## Addendum No. 6

Austin Masjid  
800 N Heatherwilde Blvd., Pflugerville, TX 78660  
June 19, 2026

Project Number: 2305

433S-2  
 1 OF 2

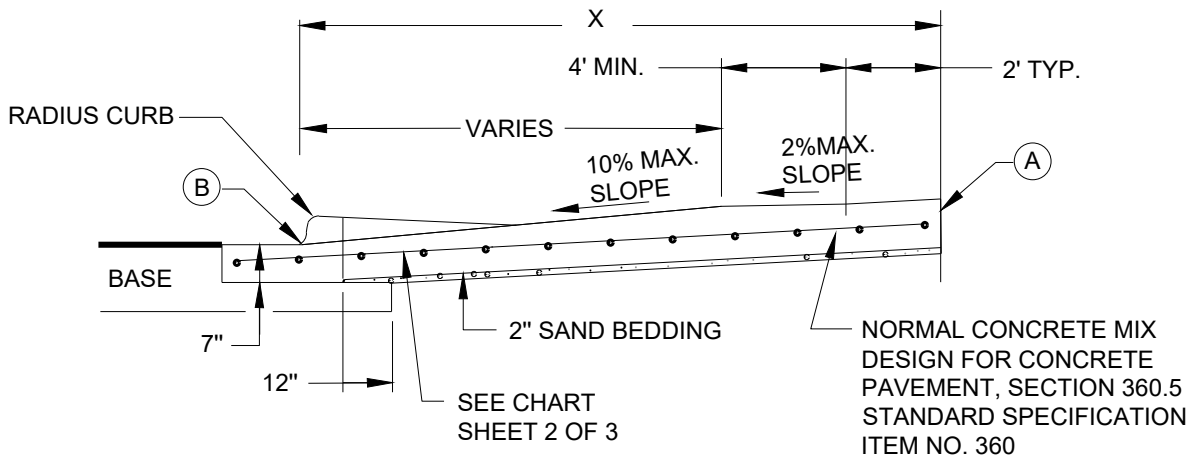
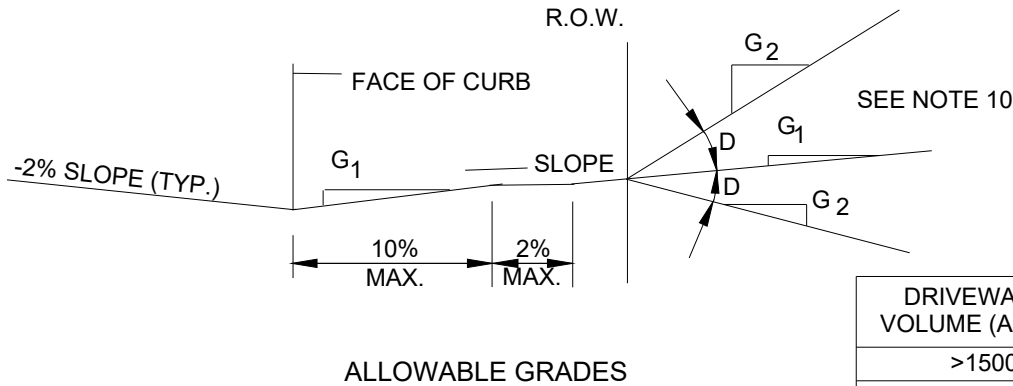
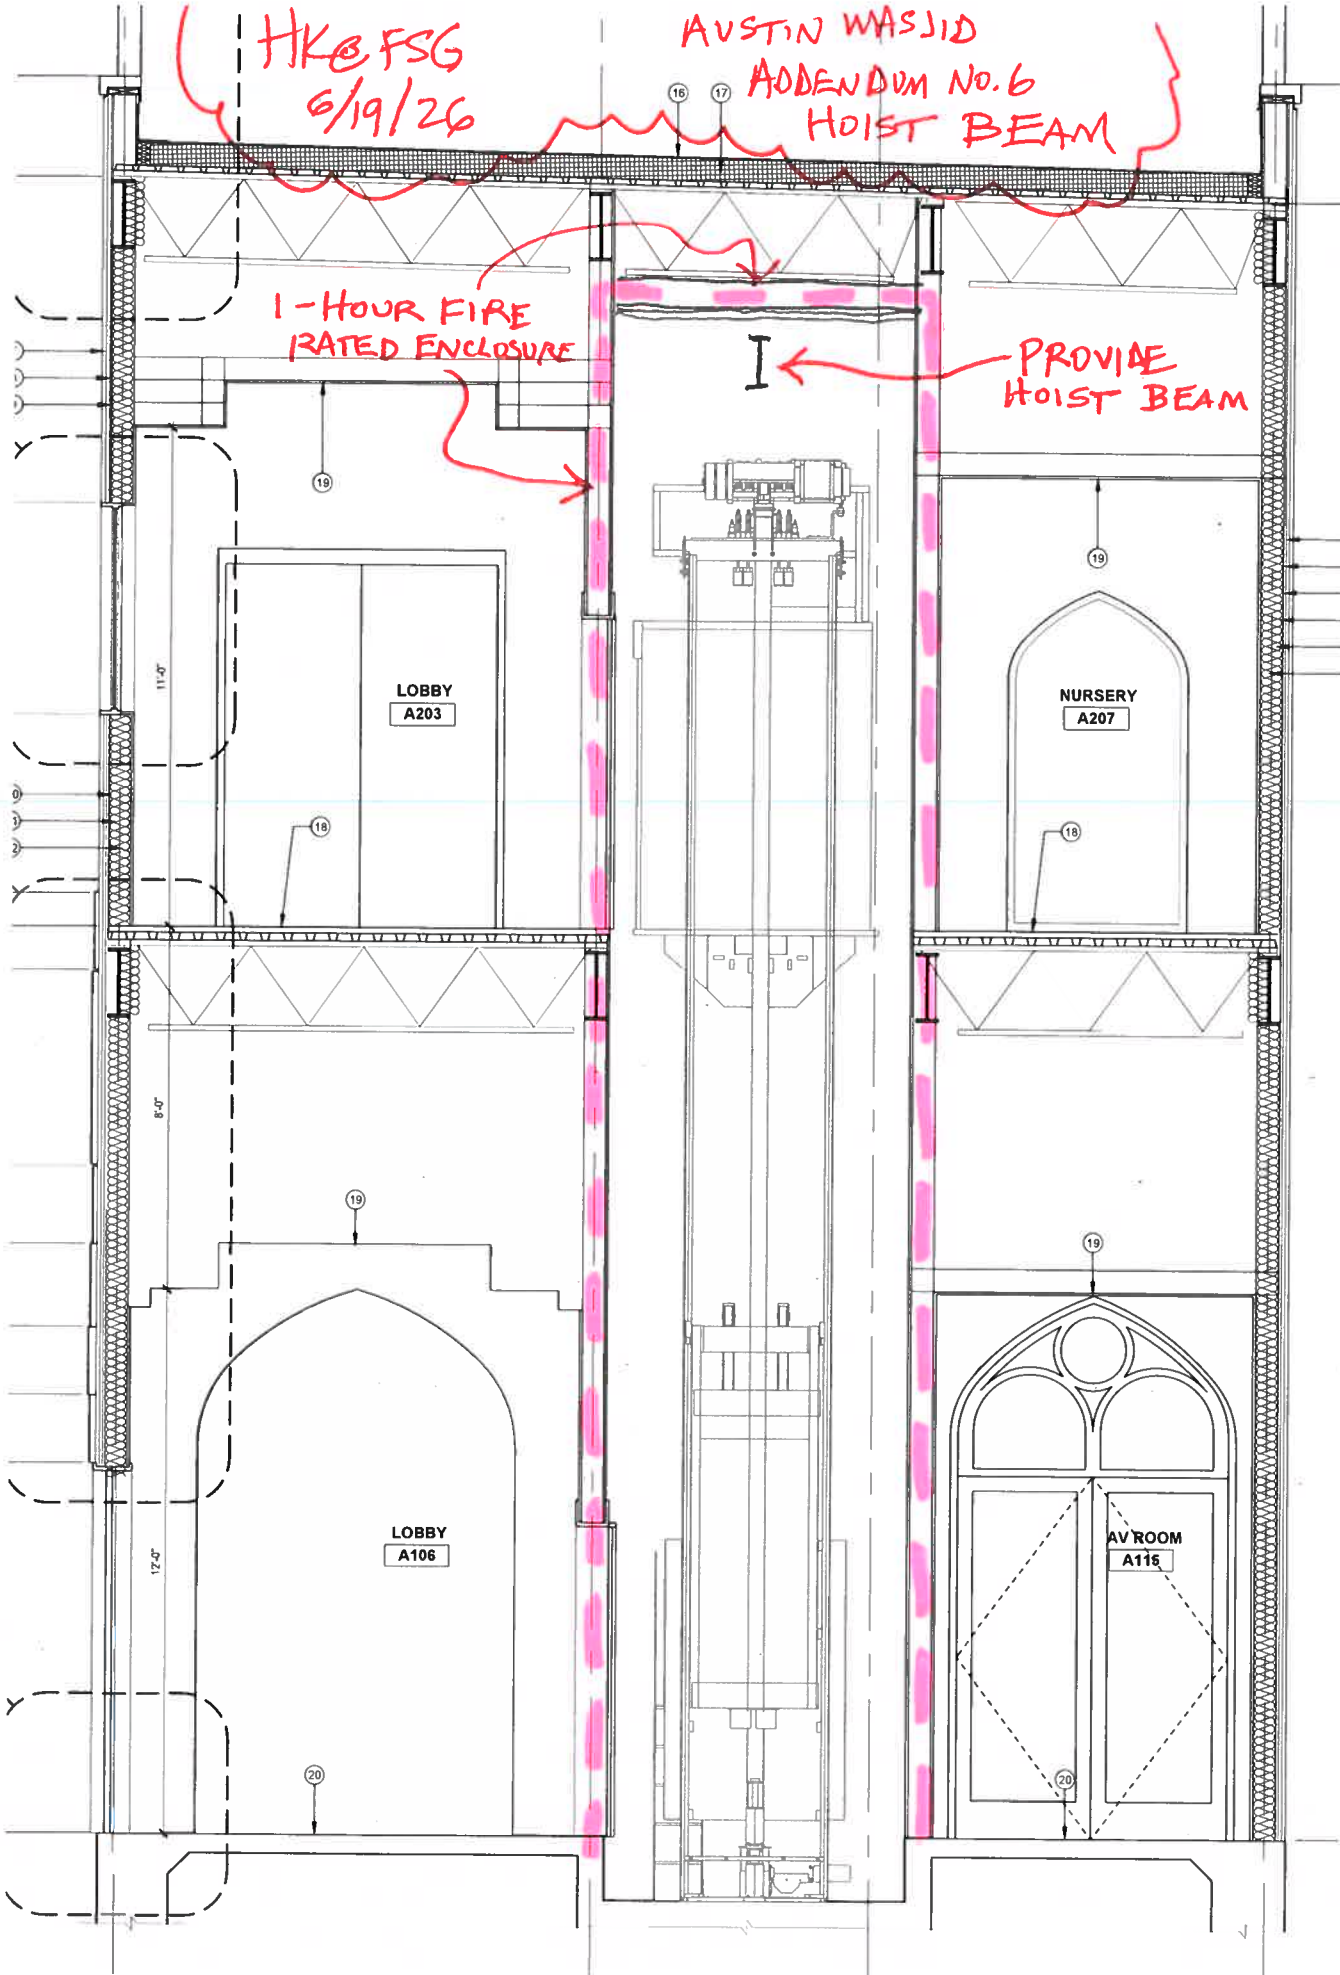
<b>A6:</b>	<b>PSCE RESPONSE: FOLLOW GEOTECHNICAL REPORT, RECOMMENDATIONS ON PAGE#16., REMOVAL OF SOIL 6" – 30" DARK BROWN CLAY.</b>
<b>Q7:</b>	<i>Curb ramp at the public ROW: drawings indicate 7" JRCP over 6" flex base per City of Pflugerville. Please confirm this section applies to the full driveway approach or only the curb cut.</i>
<b>A7:</b>	<b>PSCE RESPONSE: REFER SHEET #14 ATTACHED, CITY DRIVEWAY DETAIL. See attached AM Civil Detail 433S2.</b>
<b>Q8:</b>	<i>Confirm the fire lane width, turning radius, and surfacing material. The site plan shows fire lane access but the specification for pavement section is unclear.</i>
<b>A8:</b>	<b>PSCE RESPONSE: REFER SHEET #18 AND #19.</b>
<b>Q9:</b>	<i>Confirm the site grading and drainage plan accounts for the 2.5' undercut and select fill required by the Geotech Report. Are imported fill quantities the GC's responsibility or by allowance?</i>

**FAUX BEAM DETAIL**

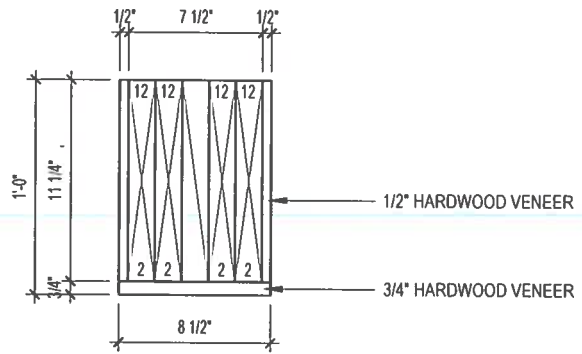
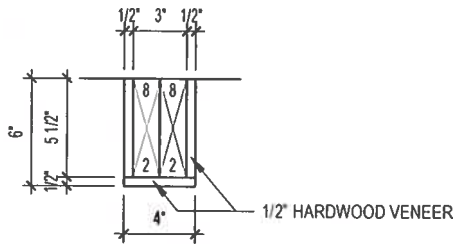
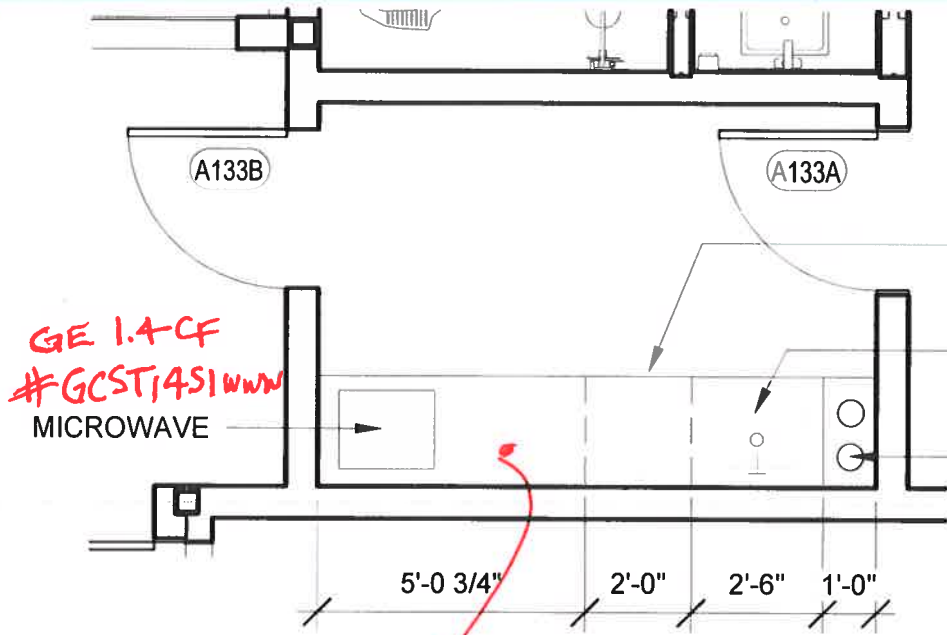
<b>A16:</b>	<i>See attached <b>AM Faux Beam Detail</b>.</i>
<b>Q17:</b>	<i>Countertops — please confirm material (quartz, solid surface, stone) and locations (Wudu, kitchen, restrooms). Are countertops carried under Div 12 or Div 06 millwork?</i>
<b>A17:</b>	<i>Typical countertops at millwork/casework, Mawaid Kitchen along pass-thru windows and VIP Kitchen is solid surface, color TBD from standard range. Other counters in Mawaid Kitchen are stainless steel tables.</i>
<b>Q18:</b>	<i>Confirm walk-in cooler/freezer manufacturer, dimensions, refrigerant (R-448A per Add 2), and whether floor pan / ramp is included.</i>
<b>A18:</b>	<i>Basis-of-Design: Bush Refrigeration combination cooler/freezer for commercial kitchen. Overall outside dimensions 12.5'x19'x8'.</i>
<b>Q19:</b>	<i>Wudu (ablution) stations — Addendum 3 revised the drain and faucet count. Please reissue the final wudu fixture schedule with total count and confirm floor-drain layout.</i>

**E5.01**

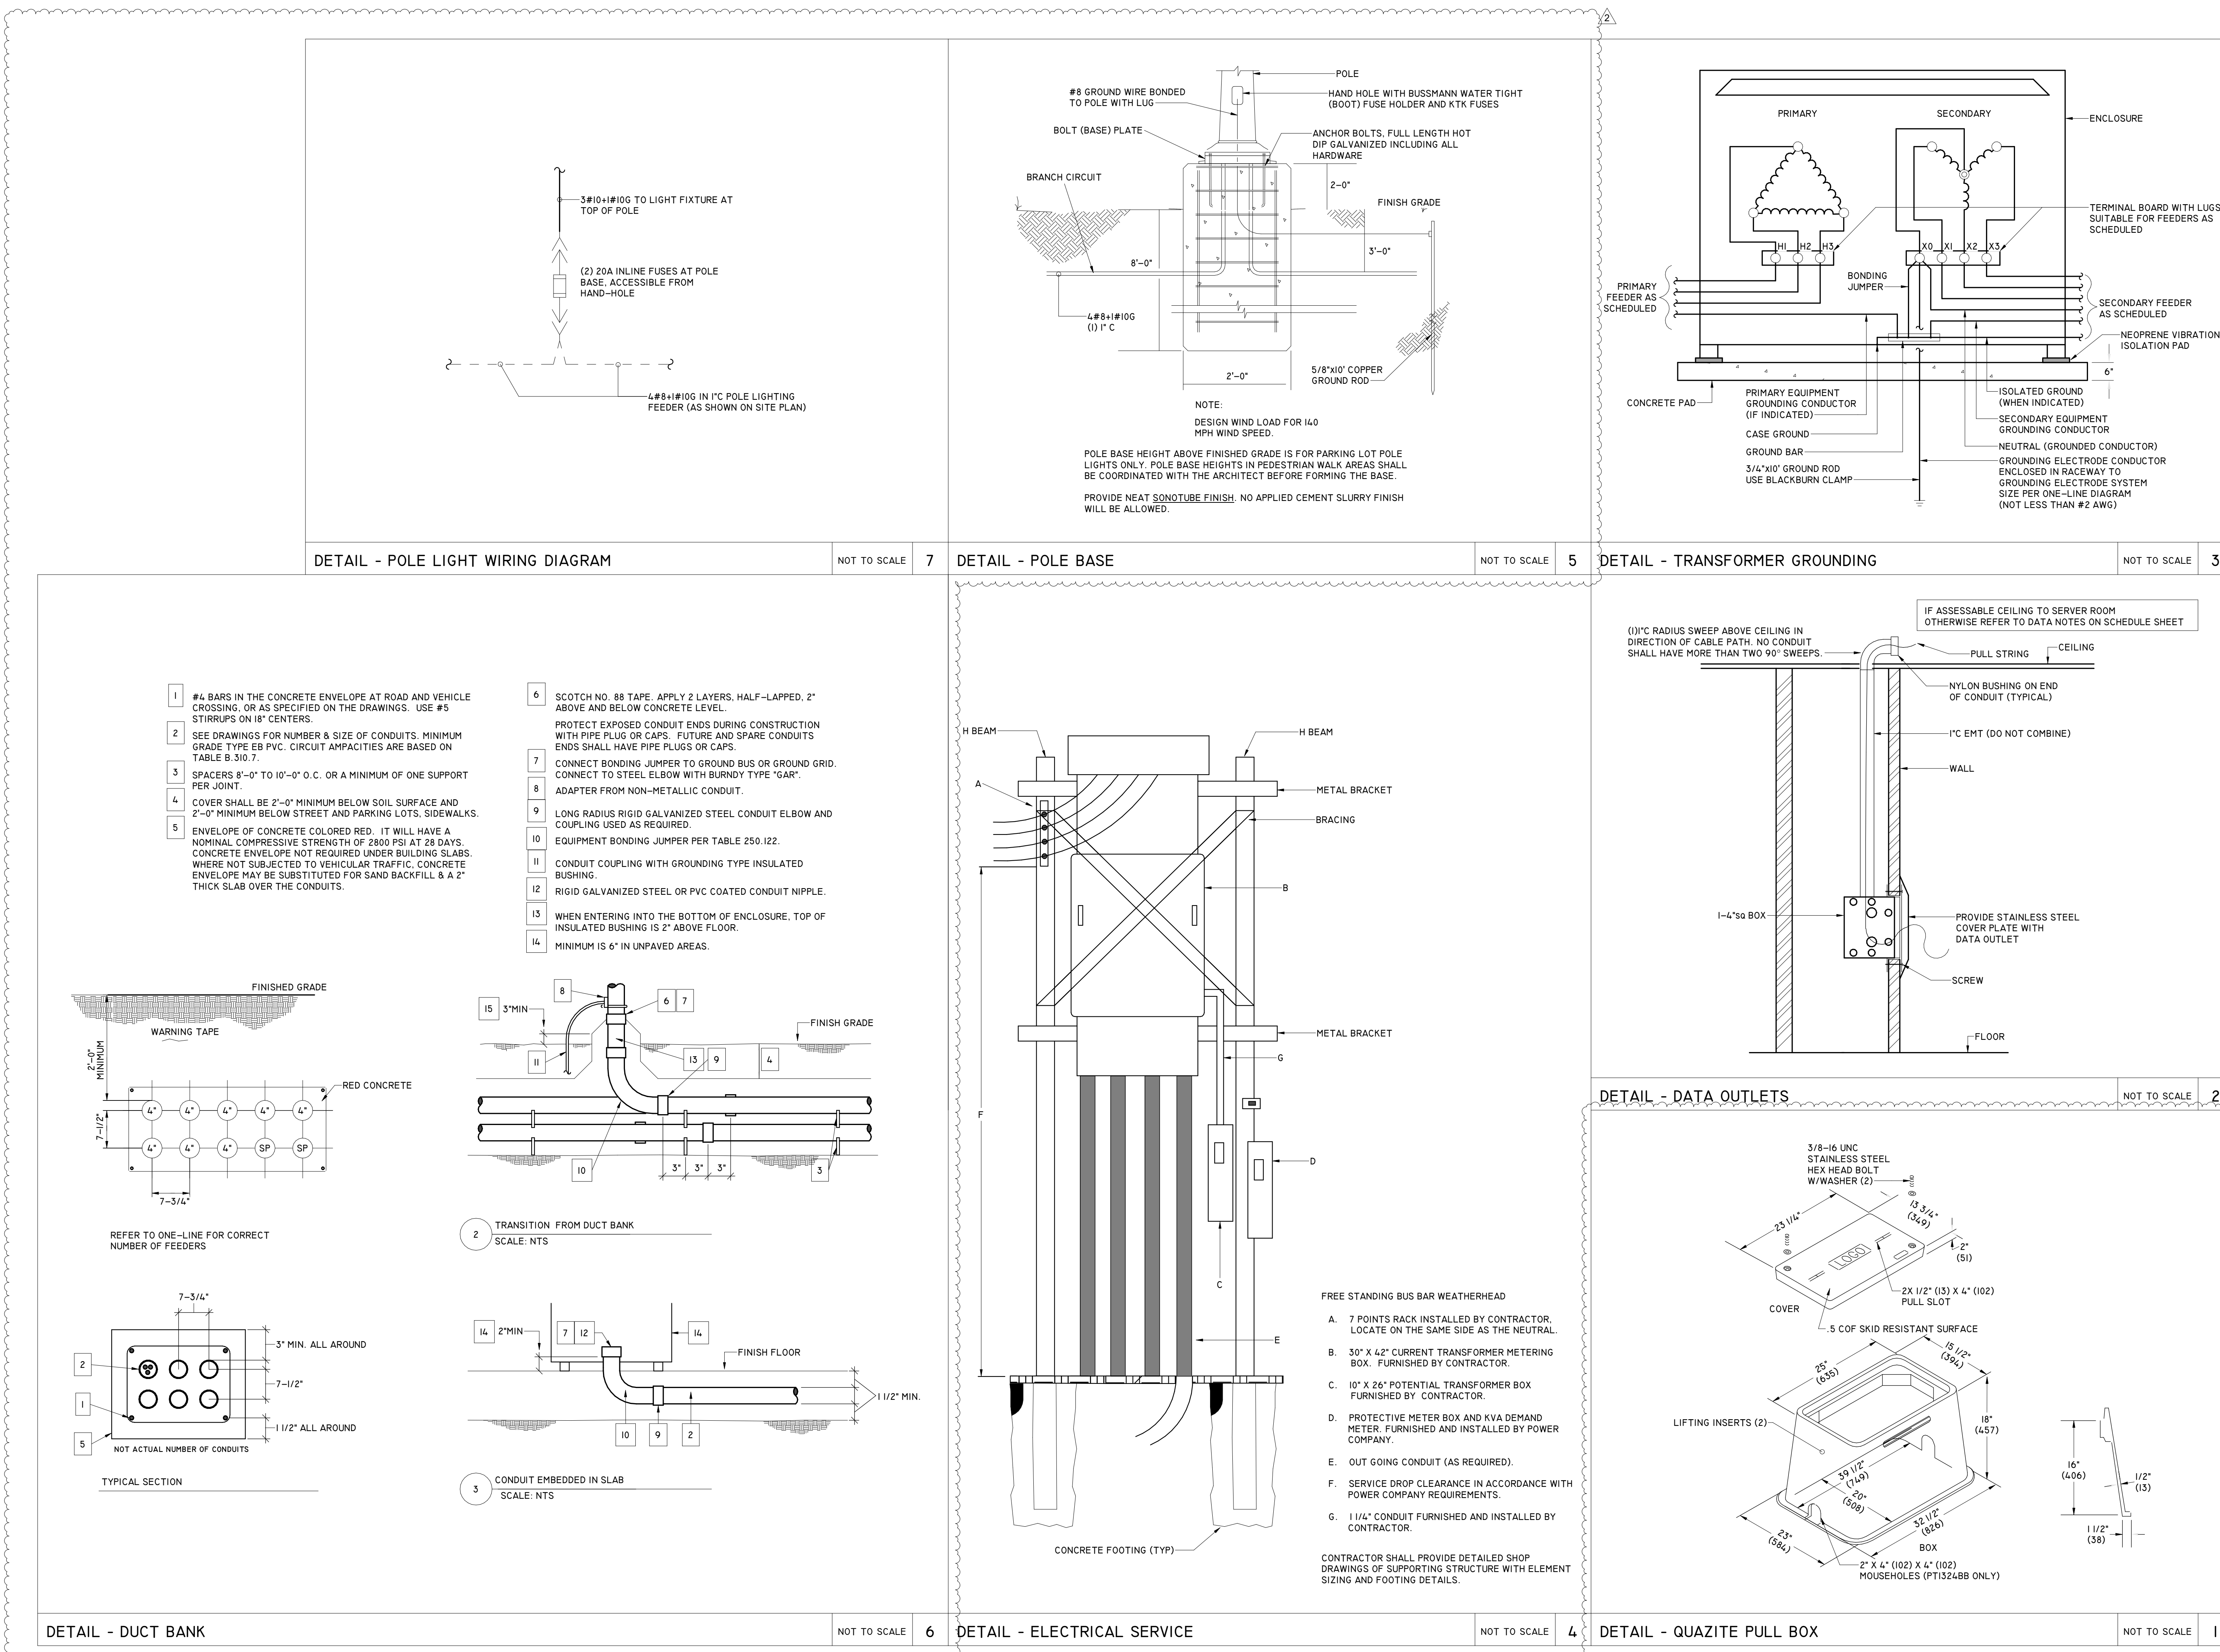
- E1.03      ADDED CIRCUITS FOR THE KITCHEN COOLER AND FREEZER TO PANEL "H1" SCHEDULE. ADDED CIRCUIT FOR EDF-1 TO PANEL "L1" SCHEDULE.
- E2.00      ADDED KEYED NOTE 5, CIRCUITS FOR THE KITCHEN COOLER, KITCHEN FREEZER, AND ELECTRIC DRINKING FOUNTAIN (EDF-1) TO FIRST FLOOR POWER PLAN
- E5.01      ADDED DETAILS FOR DUCT BANK, POLE BASE, POLE LIGHT WIRING DIAGRAM AND QUAZITE PULL BOX.
- E5.02      ADDED SHEET E5.02 WITH DETAILS FOR LIGHTING CONTACTOR, CONCRETE ENCASE DUCT BANK, EMERGENCY BALLAST, TRENCHING, DISCONNECT SWITCH, CONDUIT RACK, AND CONDUIT WALL PENETRATION.
